AGENDA PLANNING AND DEVELOPMENT COMMITTEE 12 DECEMBER 2016

| | Page |
|---|-----------|
| DEVELOPMENT APPLICATION D16-5: DETACHED DUAL OCCUPANCY - LOT 18 SECTION 54A DP 1600 AND LOT A DP 393090, 85 PIERCE STREET, WELLINGTON | |

- PDC16/10** **DEVELOPMENT APPLICATION D16-4: TWO (2) LOT COMMUNITY TITLE SUBDIVISION - LOT 18 SECTION 54A DP 1600 AND LOT A DP 393090, 85 PIERCE STREET, WELLINGTON**
APPLICANT: MR E SMITH
OWNER: MR & MRS G AND E FRENCH
LODGED: 25 FEBRUARY 2016 (ID16/2233) 39

- PDC16/11** **DEVELOPMENT APPLICATION D16-366: TWO (2) LOT SUBDIVISION LOT 62 DP 596342, 24 TAMWORTH STREET, DUBBO**
APPLICANT: MR N O'CONNOR
OWNER: MR N AND MS J O'CONNOR
LODGED: 11 AUGUST 2016 (ID16/2251) 51

Sheet No
2 of 8

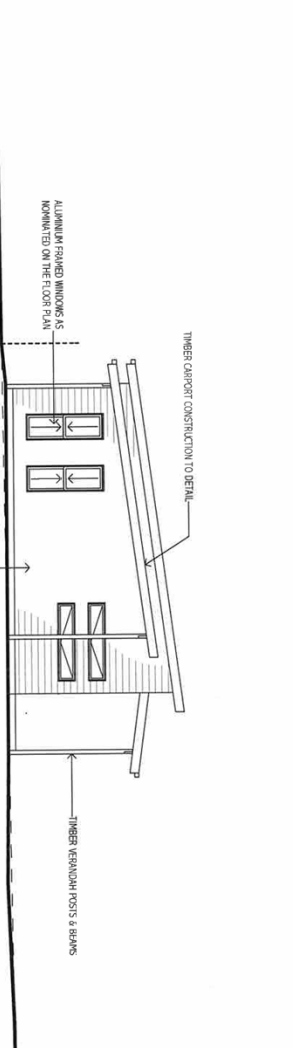
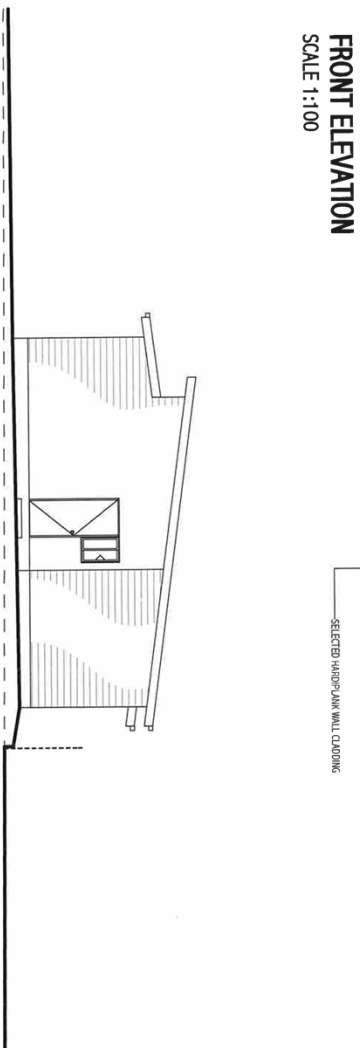
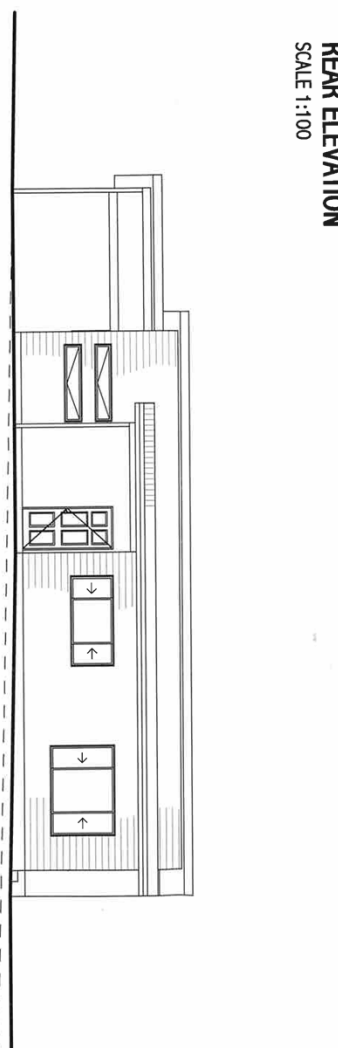
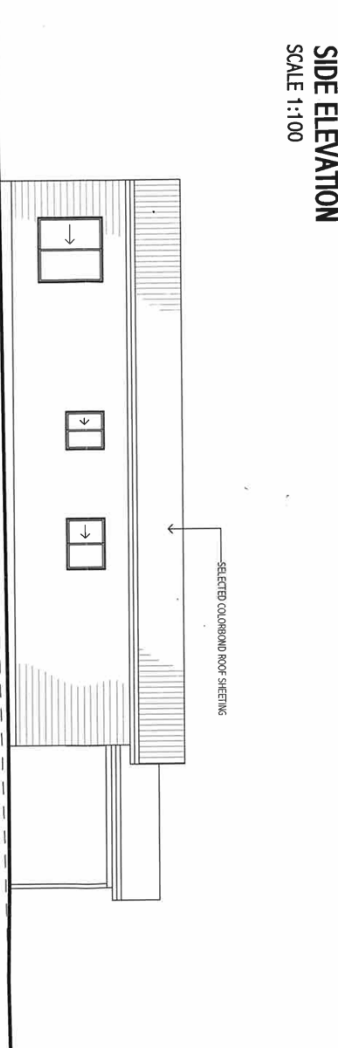
- c. **The proposed front setback is not consistent with the established setbacks in Pierce Street in accordance with the Wellington DCP 2013 (S79C(1)(a)(iii) Environmental Planning and Assessment Act, 1979);**

- e. **The proposed front fence is contrary to the requirements of the Wellington DCP 2013 (S79C(1)(iii) Environmental Planning and Assessment Act, 1979);**

The proposed development does not provide sufficient car parking upon the site. The Wellington DCP 2013 requires that each dwelling has two (2) off-street car parking spaces. The proposed development only provides one (1) off-street car parking space per dwelling, being a total shortfall of two (2) car parking spaces. Given the proposed dwellings contain three (3) bedrooms, a minimum of two (2) car parking spaces per dwelling is a reasonable requirement.

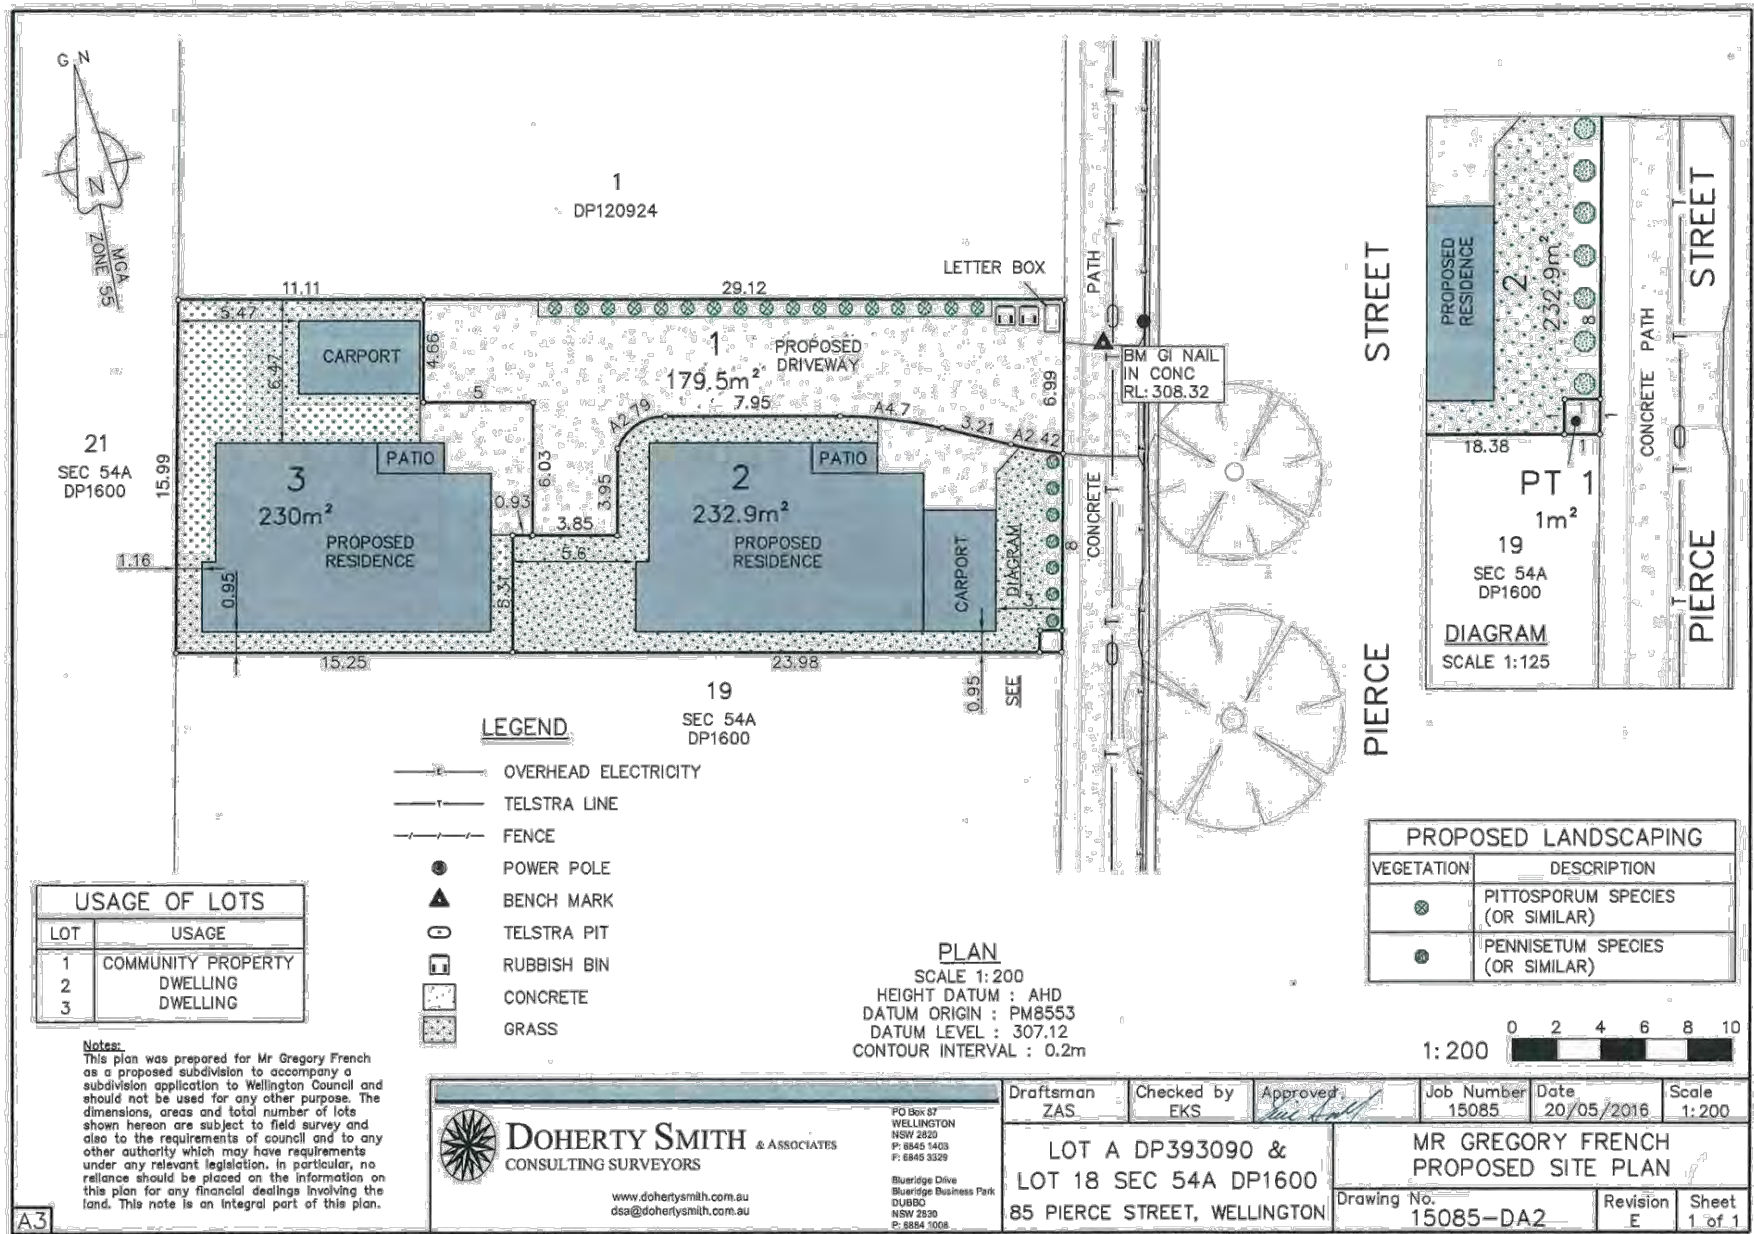
The proposed Lots 2 and 3 do not meet the minimum lot size of 600 m² in accordance with the Wellington LEP 2012 lot size maps.

The proposed subdivision is designed specifically for the separately proposed dual occupancy development lodged with Council under D16-5. Given D16-5 is being recommended for refusal, and if such recommendation for refusal is supported, the proposed lot layout would become redundant. Additionally, in such case D16-5 is refused, the proposed lot layout would be a poor design and be an inefficient use of land, contrary to the objectives of the Environmental Planning and Assessment Act, 1979.

This Plan has been designated by
Dubbo Regional Council as:
PROPOSED
Drawing No. FLOOR PLAN
Date: *2/12/16* Rev. *B*

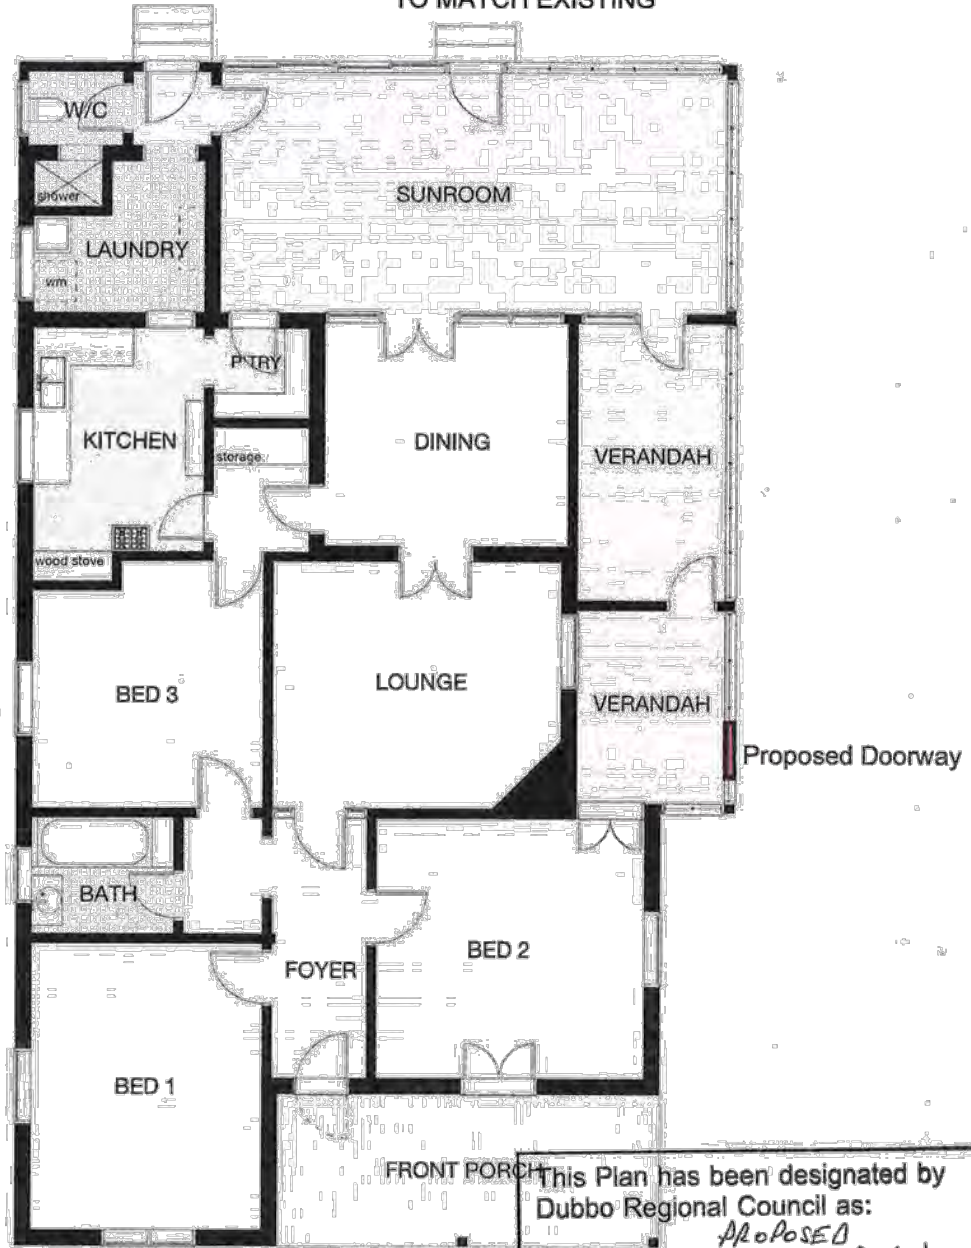
The windows of the dwelling's northern sunroom are proposed to be removed to create an open verandah and a door way opened along the eastern wall to provide compliant private open space under DCP Chapter 2.1 Residential Development. These works are considered to be sympathetic to the existing dwelling as they will leave the rear brickwork intact and provide a balustrade for the proposed verandah. Only a small section of brick work is proposed to be removed for the eastern doorway subject to further development consent.

Add Door
NORTH FACING WINDOWS TO BE REMOVED
FINISH BRICKWORK WITH TRIM
TO MATCH EXISTING
